14_16 Gutter Slopes

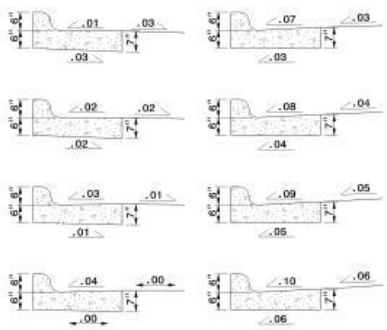
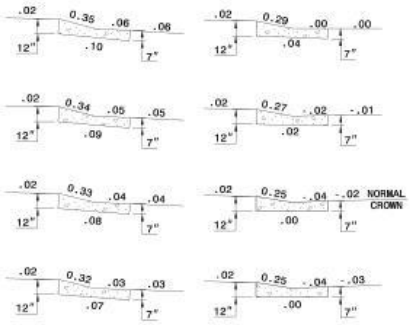
Question:
Does the 1'-6" c&g (stnd. 846.01) follow the same rules, concerning the gutterpan super, as the 2'-6" c&g?

Answer:
Yes, currently Criteria draws the gutter slopes for the 1'-6" curb and gutter in the same manner as the 2'-6" curb and gutter.

Type 1 (2' - 6" or 750mm), Type 2 (1' - 6" or 450mm), and Type 10 (2' - 9" or 800mm) curb and gutters follow this type of rollover transition from the mainline pavement (superelevation rate).

Type 7 (Expressway Gutter), Type 8 (Shoulder Berm Gutter), and Type 11 (Valley Gutter) follow this type of rollover transition from the mainline pavement (superelevation rate).
